North Dakota Department of Transportation

ADDENDUM 1 – JOB 6

TO: All prospective bidders on project SOIB-5-094(087)059, Job No. 6 scheduled for the February 5, 2016 bid opening.

STATE	PROJECT NO.	SECTION NO.	SHEET NO.
ND	SOIB-5-094(087)059	8	2

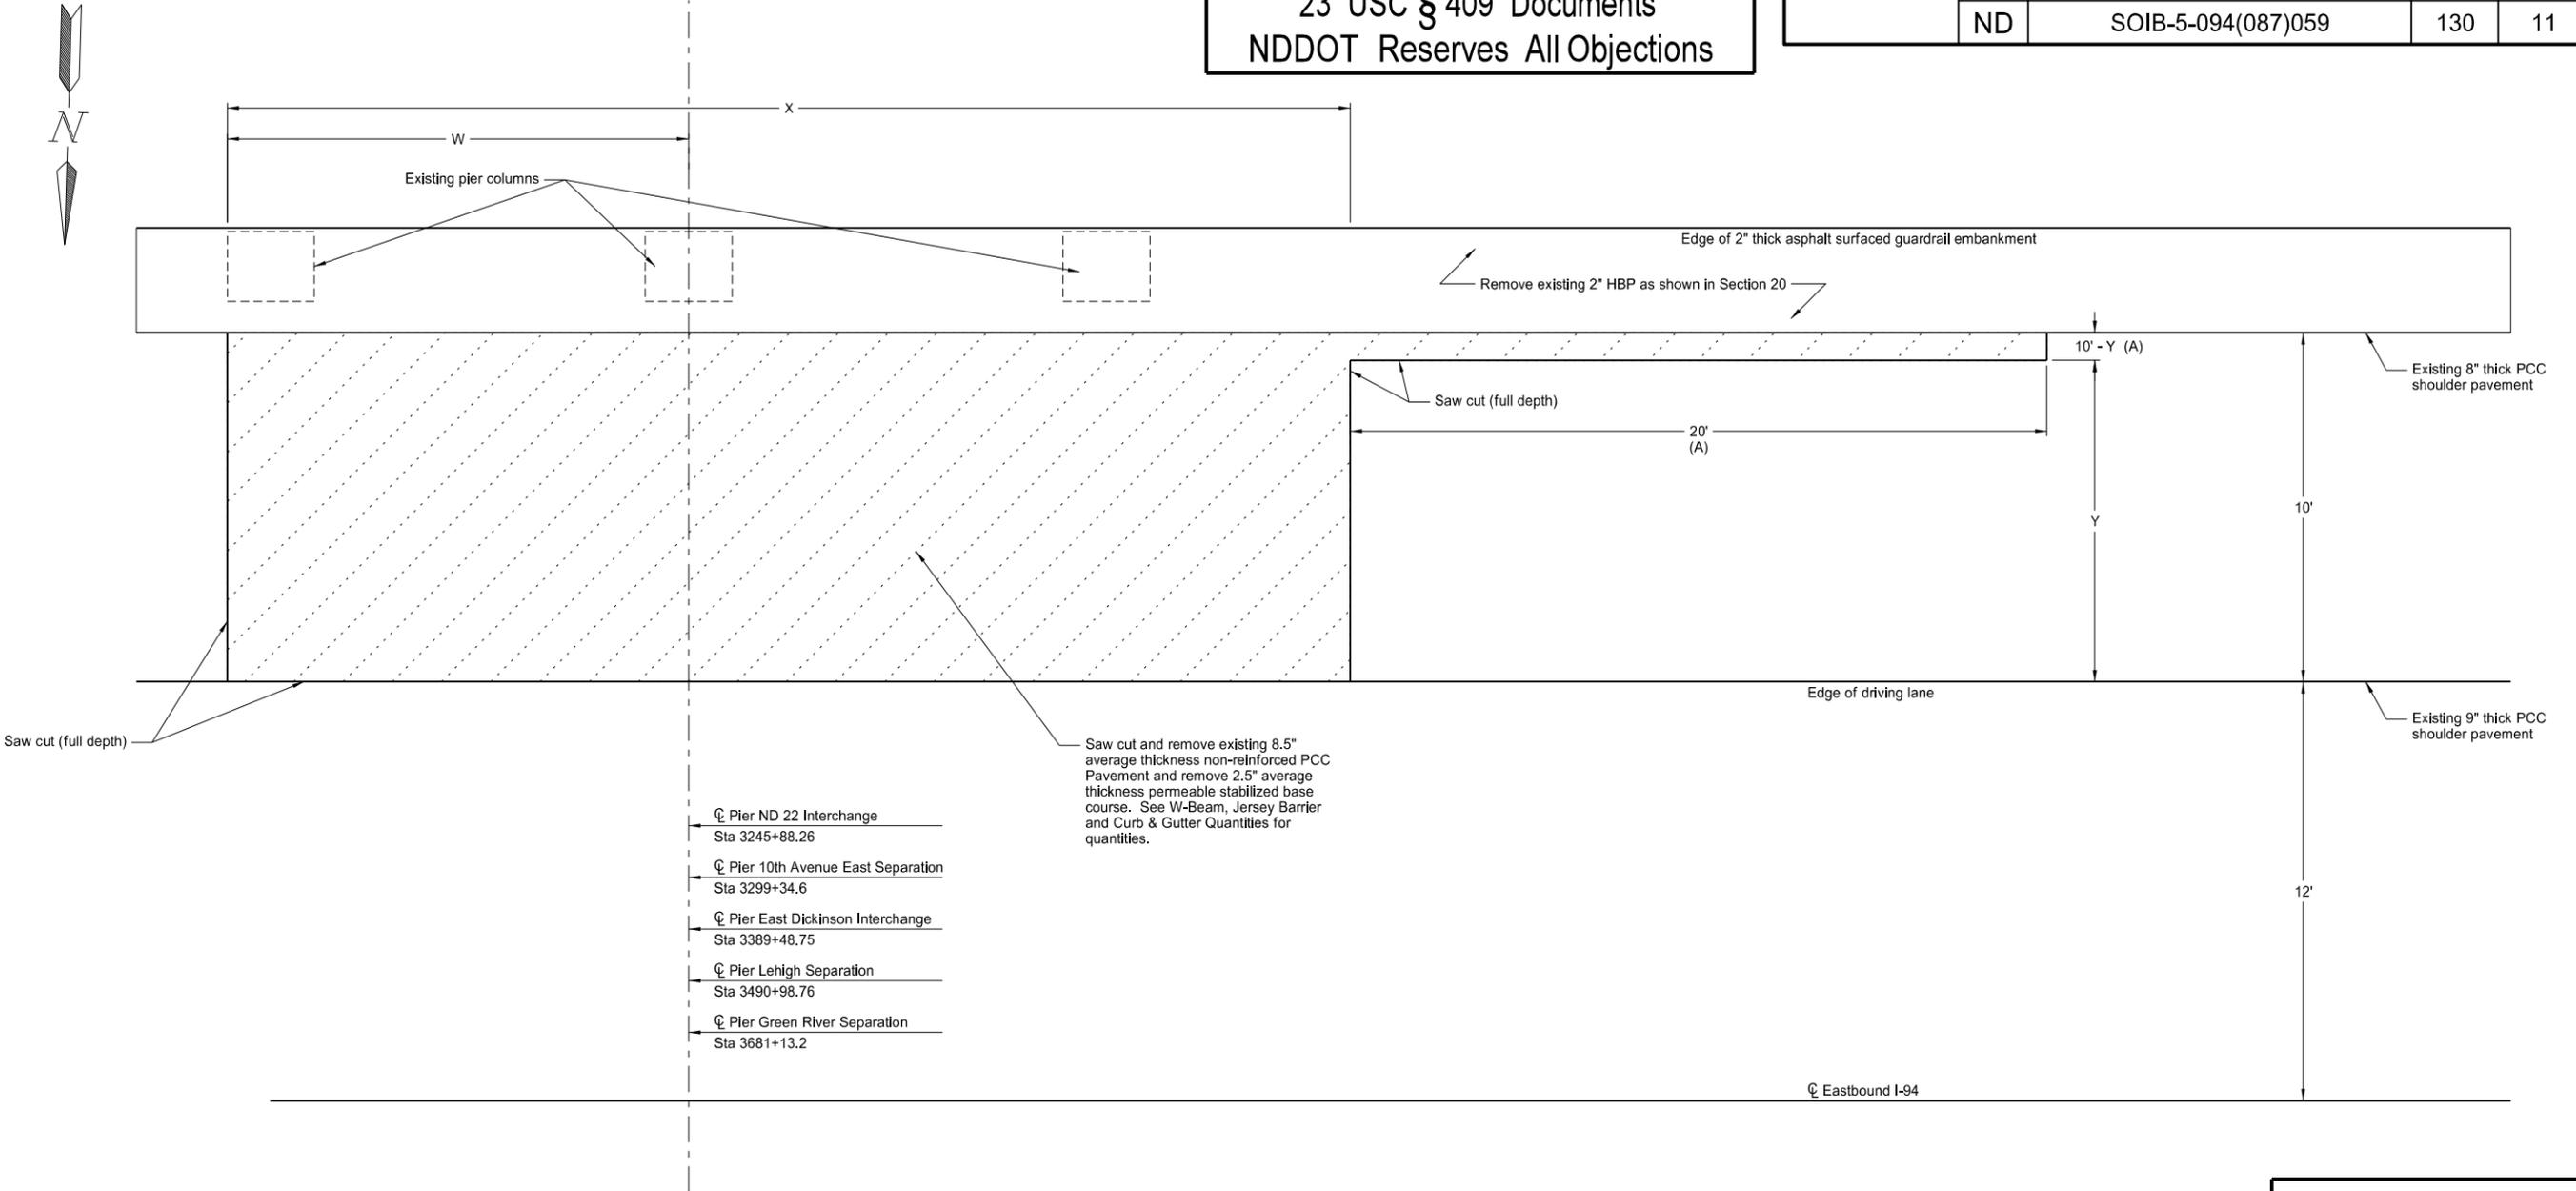
Item 704 1043 ATTENUATION DEVICE-TYPE B-65; 5 EA was added.

Jersey Barrier and Curb & Gutter Details Outside Pier Protection
 ND 22 Interchange, RP 61.476
 10th Avenue East Separation, RP 62.486
 East Dickinson Interchange, RP 64.204
 Lehigh Separation, RP 66.118
 Green River Separation, RP 69.714
 Eastbound I-94

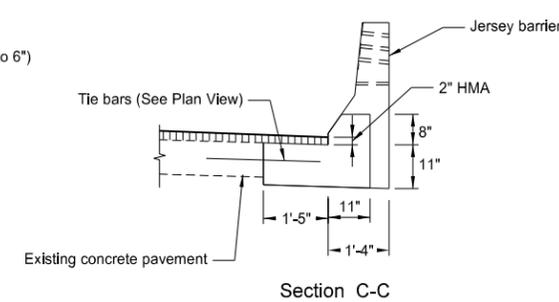
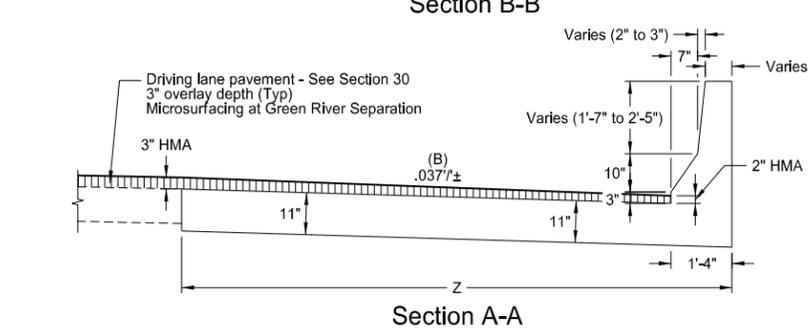
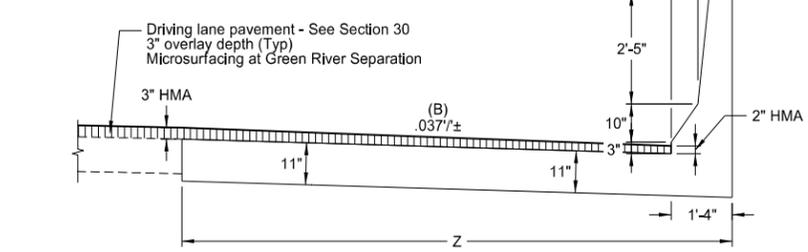
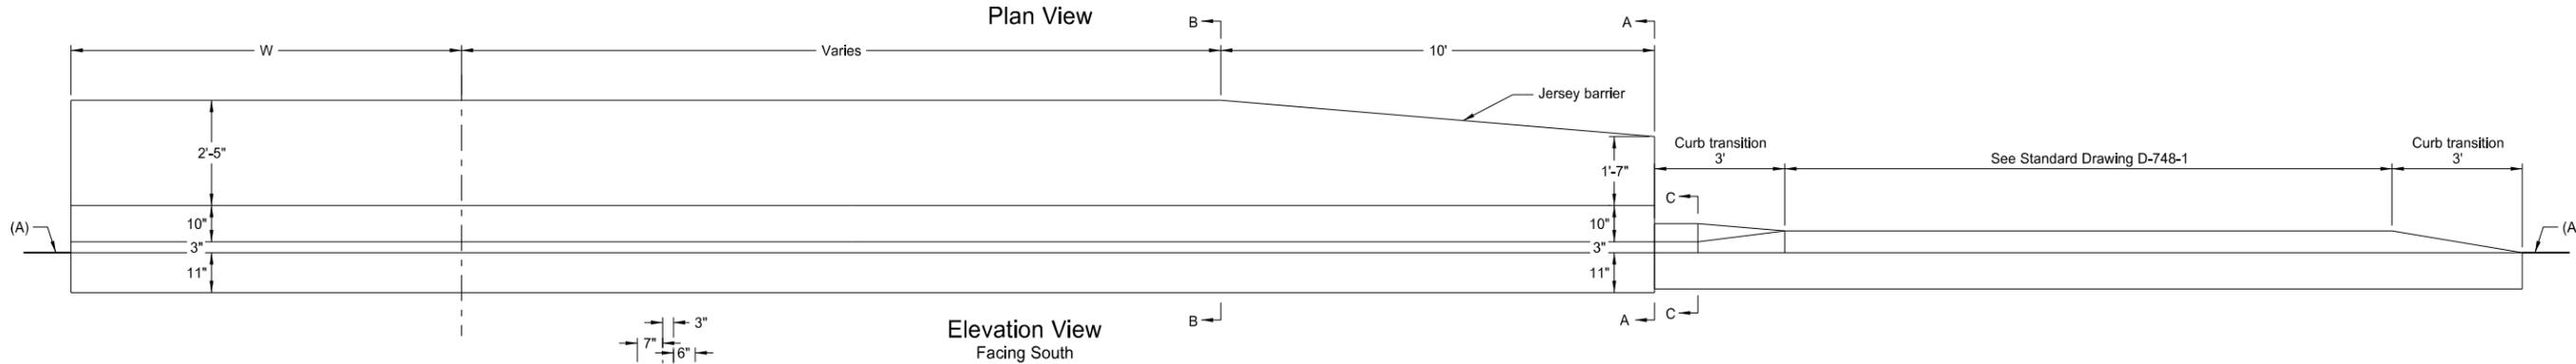
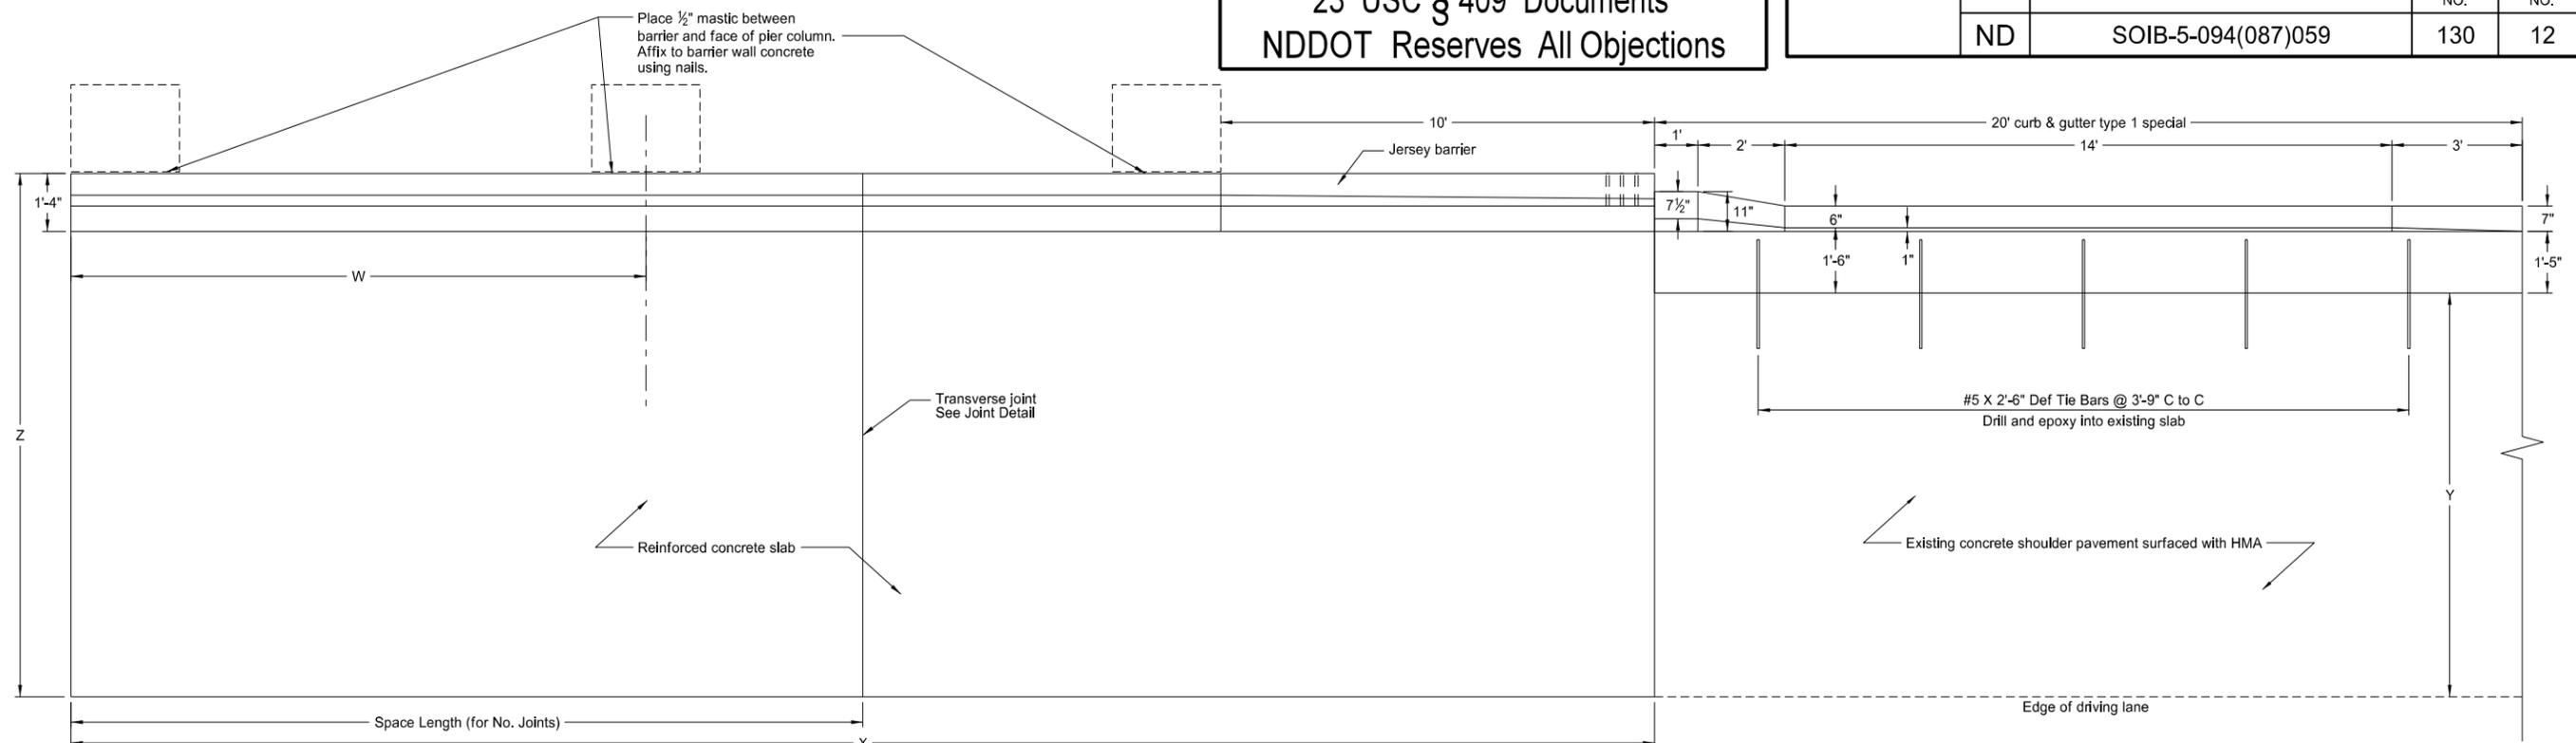
Revised section A-A, B-B and C-C to construct the jersey barrier slab flush with the existing PCC pavement. In addition, the HMA overlay is to be paved on top of the jersey barrier slab.
